# CHAPTER 5

## Draft EIR Text Revisions

### 5.1 Introduction

**Figure 4.4-3a**  
Desert Tortoise Critical Habitat

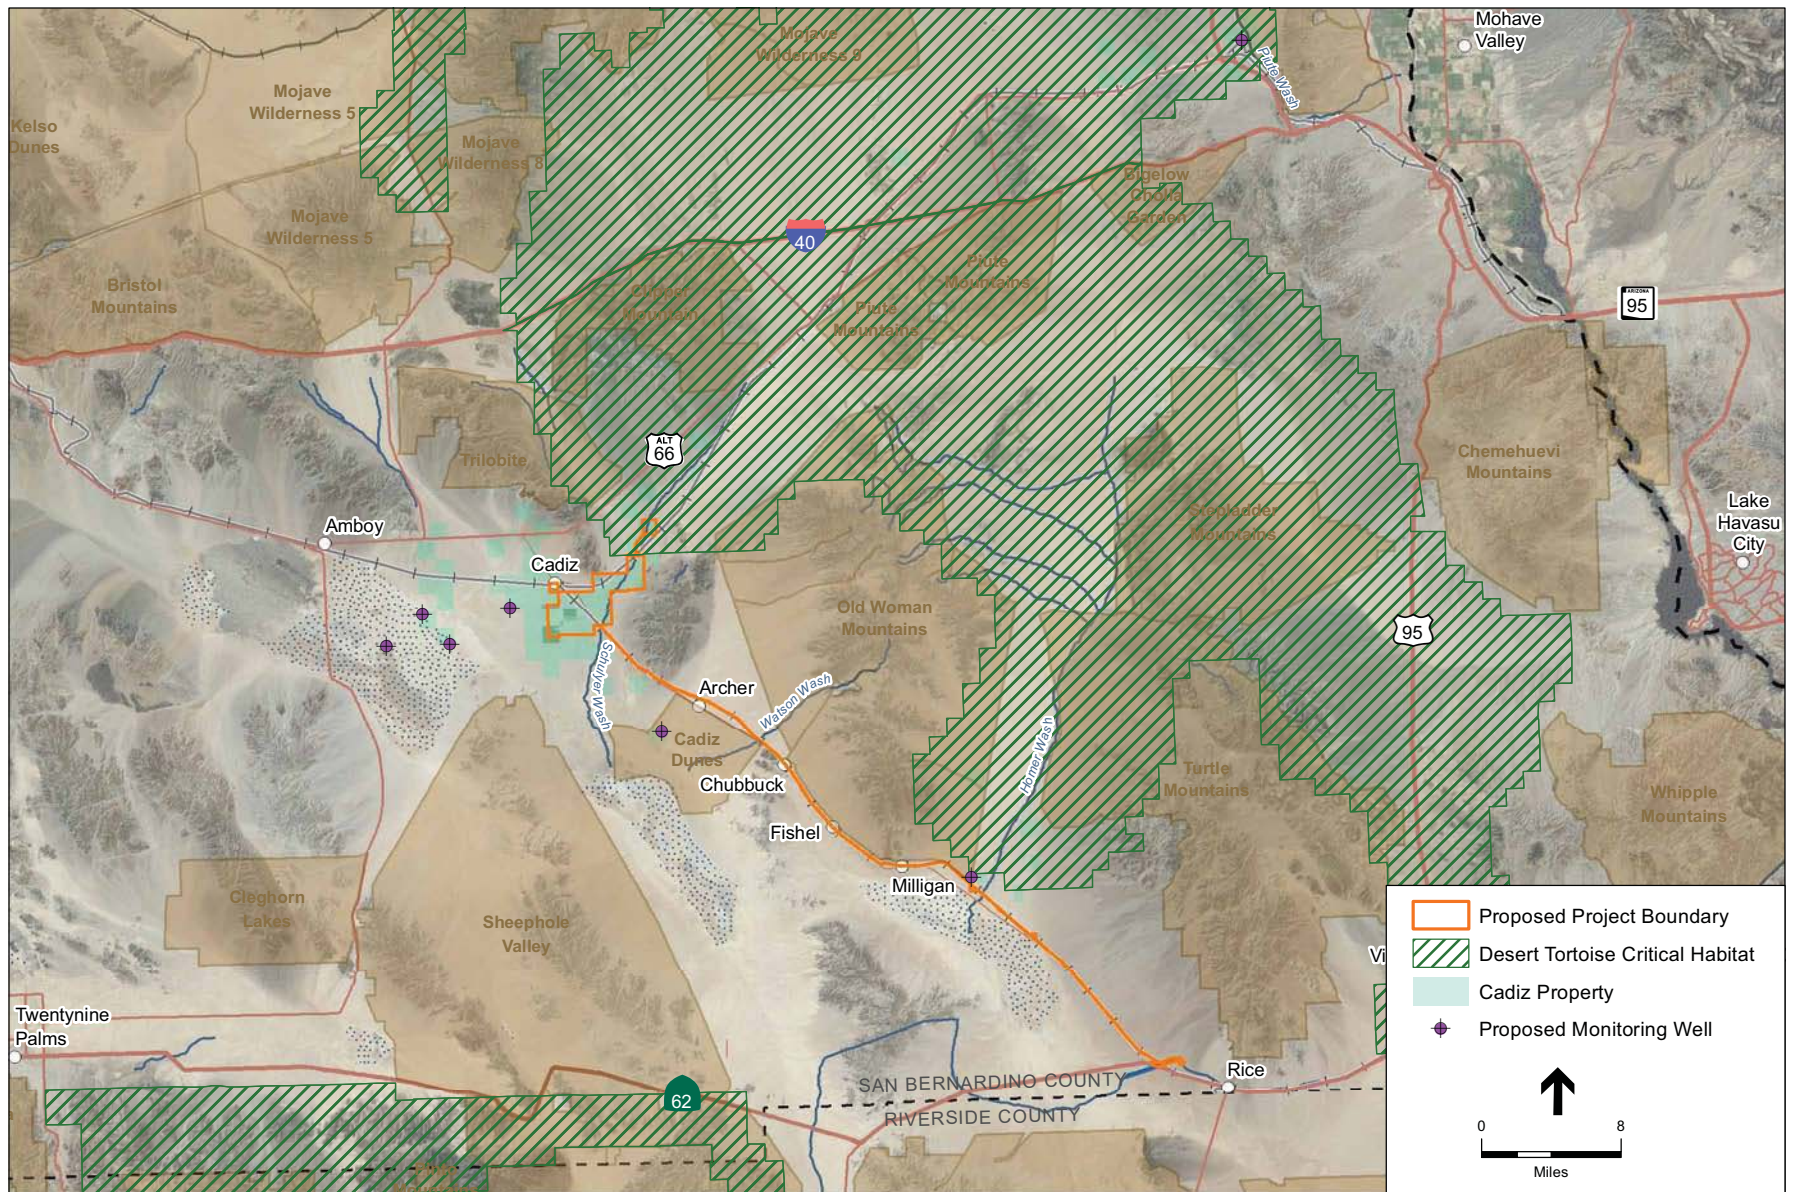
Section 4.4.1, p. 4.4-20, Figure 4.4-3a is revised as shown on the following page.

**Figure 4.9-12a**

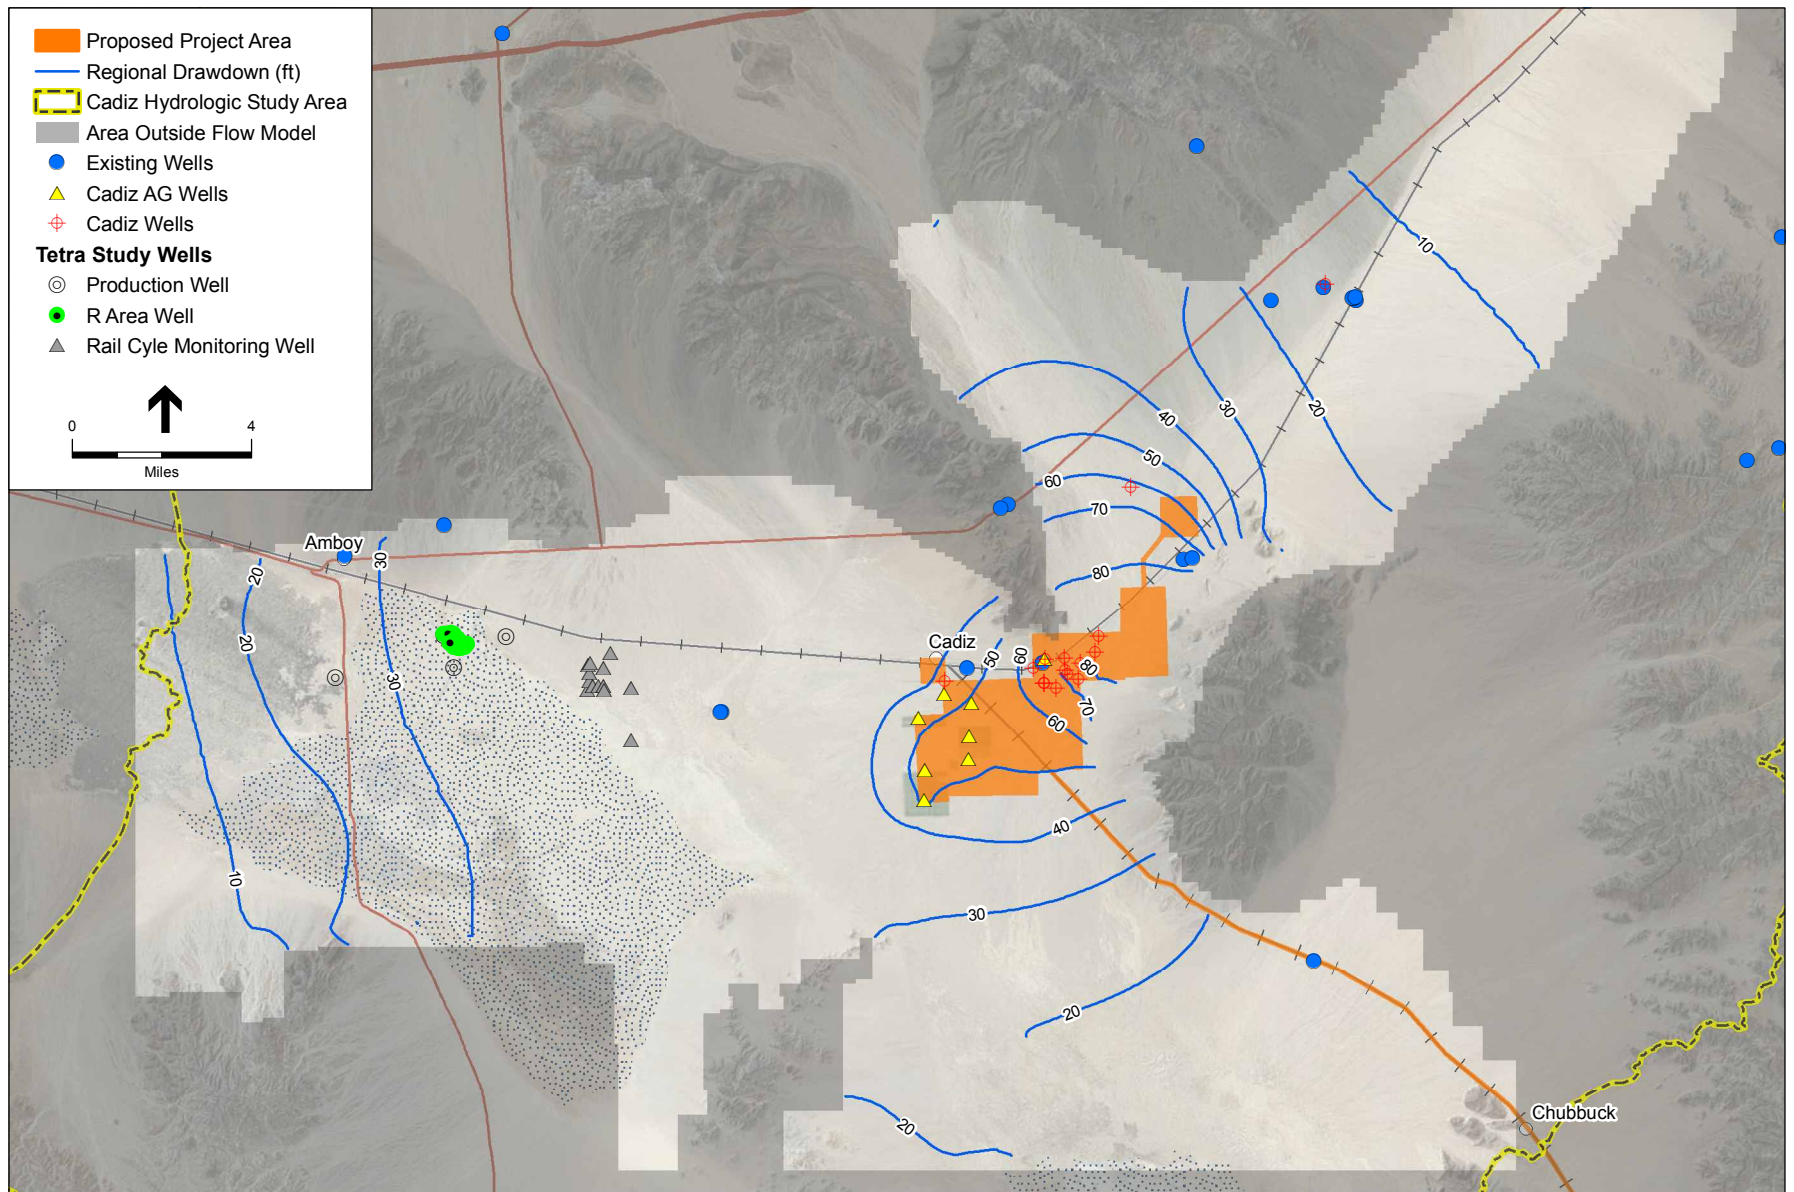
Section 4.9.3, p. 4.9-67 through 69, **Figures 4.9-12a, 4.9-13a, and 4.9-14a** have been added on the following pages in **Response A\_NPS-84**.
